**ISSUE:** Permit to Demolish/Capsulate (partial) and Certificate of Appropriateness for alterations

**LOCATION:** Old and Historic Alexandria District  
323 South Washington Street

**STAFF RECOMMENDATION**

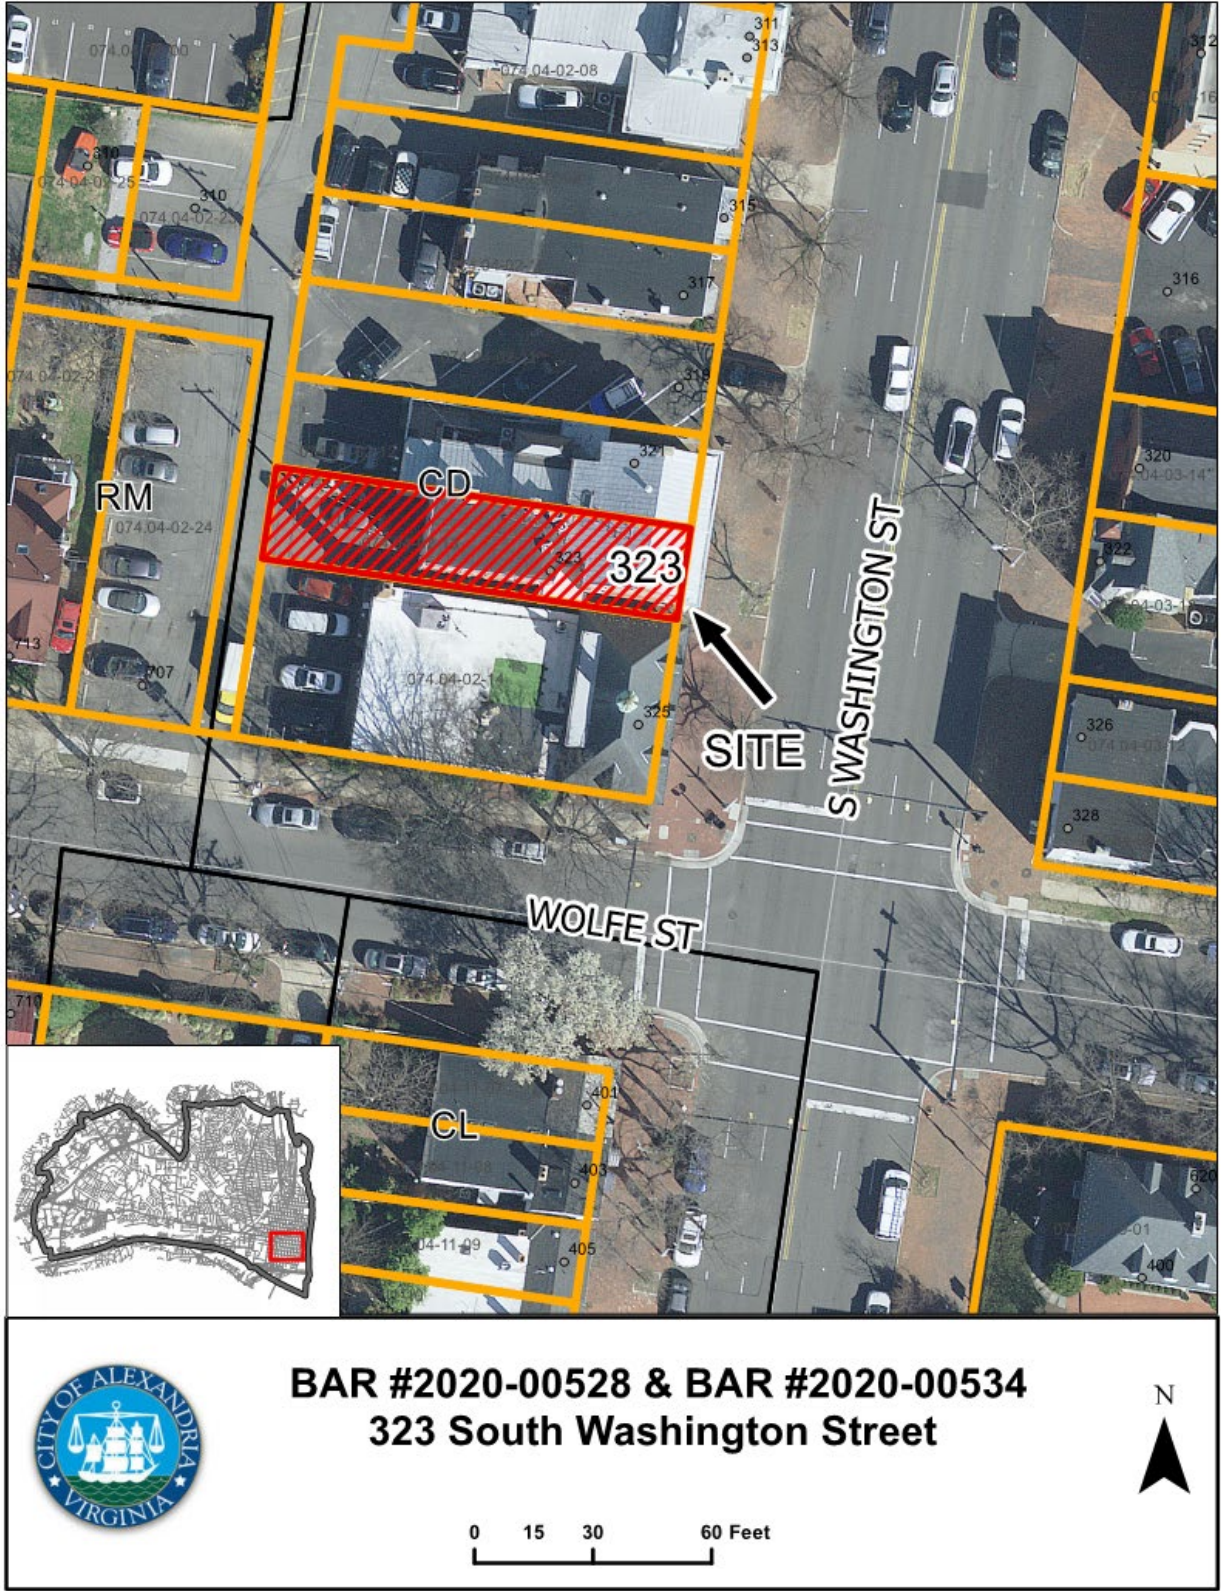
Mr. Adams found the proposed staircase inappropriate for the building, he stated that there are no similar fire stairs in the historic district that were approved by the Board. He would prefer that the access to the upper stories be done through the building's interior or an enclosed addition to the rear.

In general, the Board did not have issues with the proposed staircase since it is at the building's rear and not visible from Washington Street, but they agreed that the proposed staircase should not be a utilitarian staircase and should have a better design since it will be the main access to the upper stories residential units. They also found an open staircase less intrusive than an enclosed addition.

Figure 3 - proposed freestanding staircase

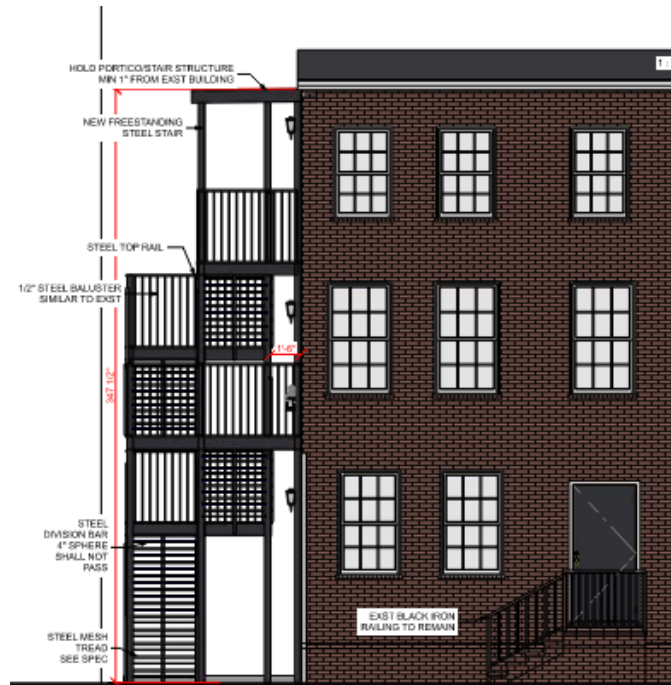
The applicant worked with staff to address the Board's concern that the staircase's utilitarian design of the previous proposal was not appropriate since the structure will be the primary access to the upper stories' residential units. The Board recommended that the applicant restudy the structure's design to reflect its primary entrance rank. Since then, the applicant has refined the design of the staircase by making it freestanding, slender with ½" spindles, and by adding a steel portico roof above the top floor entrance landing (Figure 3). The applicant is also proposing two finishing options for the structure: Option A (Figure 4), the structure will be painted black to match other existing railings on the building, and Option B (Figure 5), the structure will be painted to match the rear/west elevation wall which will make the structure less evident.

attached to the rear/west elevation wall. Now, the applicant has modified the plans to incorporate staff's recommendation to make the staircase freestanding, leaving breathing room between the structure and the wall (1'-6"), which will require fewer anchoring points and will not obstruct the existing windows as the Board recommended. However, the applicant failed to include a masonry treatment report as requested, therefore, staff recommends the applicant to work with staff and submit a thorough masonry treatment plan prior the issuance of any permit.
